Montgomery Lane Bike Lanes (CIP Project No. 500119), Mandatory Referral No. MR2019023

Staff Recommendation: Approval to Transmit Comments

MANDATORY REFERRAL REVIEW

Figure 3: Floating bus stop at Pearl Street

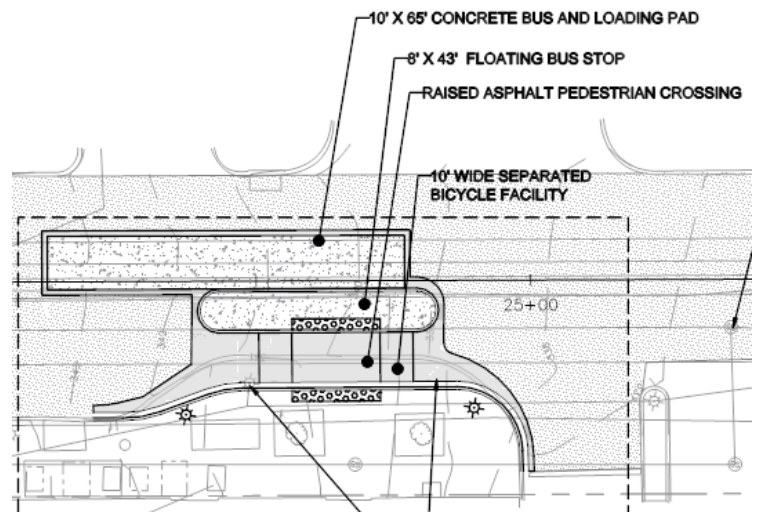
2. **At all locations where floating transit island are provided (East Lane, Pearl Street), consider installing:**

- a. **Raised pedestrian crossings between the floating transit island and the sidewalk to allow transit users to cross the separated bike lanes at a continuous elevation and encourage bicyclists to slow down and yield to transit users crossing the bikeway.**

- c. **Lean rails along the back of the floating bus stops to define the space and prevent conflict between bicyclists and transit users.**

Lean rails are shown in Figure 11 along the back of the bus stop. They channel transit users to designated bikeway crossings while also providing those waiting for the bus a place to lean against.

Figure 5: Accessible On-street Parking in front of 4550 Montgomery Avenue

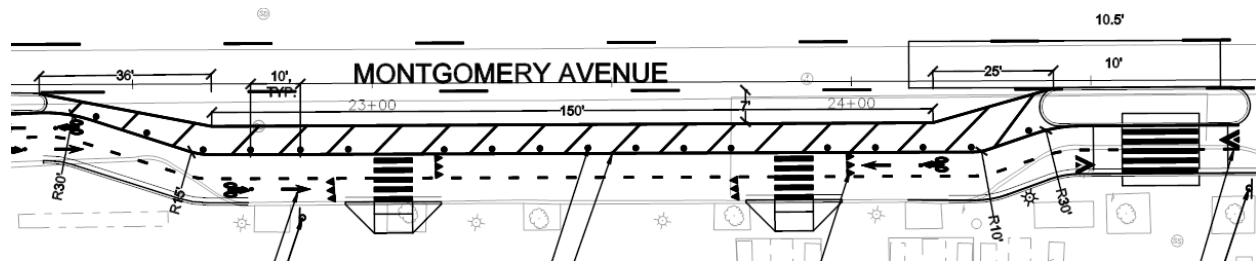
- b. At 4550 Montgomery Avenue, provide an ADA-compliant pedestrian clear zone across the parking garage driveway.
 - c. At the intersection of Pearl Street and Montgomery Avenue, add a crosswalk on the east leg and install curb ramps on the northeast and southeast corners.

Figure 14: Recessed Stop Bar on East Lane

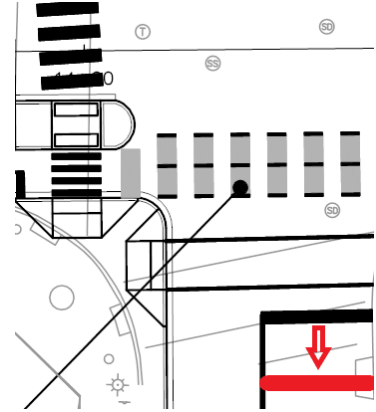
It may also be helpful to reinforce the right-turn-on-red restriction by moving the vehicular stop bar on intersecting streets further back, as shown at East Lane in red in Figure 14. Recessing the stop bar would likely have the additional benefit of improving the ability for larger vehicles to safely navigate the protected intersection treatments proposed in Recommendation #1 at these locations by allowing a wider effective turning radius, as shown in Figure 15.

Figure 16: Two-Stage Queue Box at Pearl Street

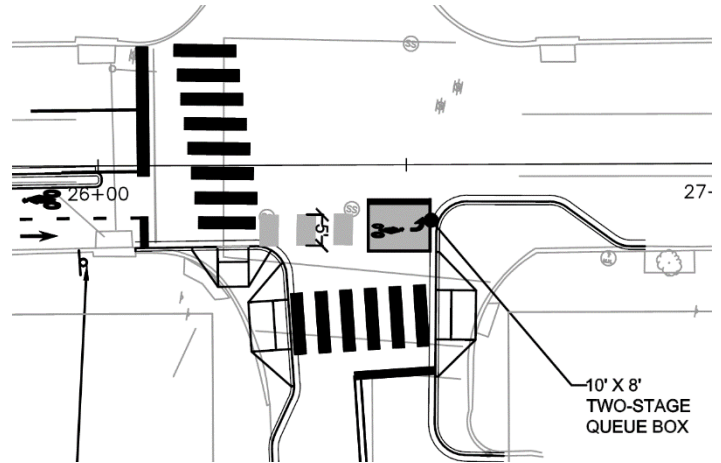
6. **Improve the ability of eastbound bicyclists to continue traveling past Pearl Street by altering the proposed curb extension at the southeast corner of Montgomery Avenue and Pearl Street.**

While many bicyclists will choose to continue north along Pearl Street and utilize the two-stage queue box as designed, others will want to continue east on Montgomery Avenue toward East-West Highway. This movement needs to be accommodated.

One idea is to design a treatment similar to the one in Figure 17 from the Planning Department’s Bicycle Facility Design Toolkit. This treatment allows eastbound bicyclists to transition into a lane shared with traffic *after* passing through the intersection, rather than *in* the intersection as currently designed. Transitioning after the intersection is preferable from a safety standpoint because the bicyclist can establish themselves in the travel lane with no motor vehicles behind them.
